# Access Compliance Report

## Public Rights-of-Way

### (Pedestrian Signals)

| ADA ID: C9869113A446                    | Signal Type: One Push Button-APS | Overall Compliance: No                  | Severity Score: BTN 1: N/A BTN 2: N/A No BTN: N/A |

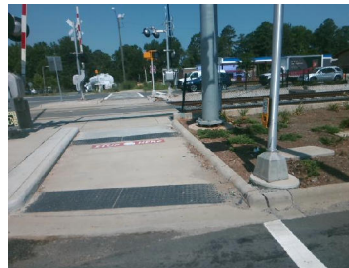
Surveyor Notes: TEXT HT 5/16

PROW/ADA: R410.6, R406.2, R404.7.3,  
R209.1, MUTCD 4e.10

| No B 1 Verbal Walk Cycle?           | Yes | N/A B 2 Verbal Walk Cycle?          | N/A |

| Compliance | Description                             | Data    | Compliance | Description                            | Data |
|------------|-----------------------------------------|---------|------------|----------------------------------------|------|
| No         | B 1 Sign Lettering & Contrast?          | No      | N/A        | B 2 Sign Lettering & Contrast?         | N/A  |
| No         | B 1 FWD Approach Reach (in)             | 17.5    | N/A        | B 2 FWD Approach Reach (in)            | N/A  |
| No         | B 1 PARA Approach Reach (in)            | 17.5    | N/A        | B 2 PARA Approach Reach (in)           | N/A  |

Possible Solutions: Remove & Replace  
Replace APS Button With New APS Button.
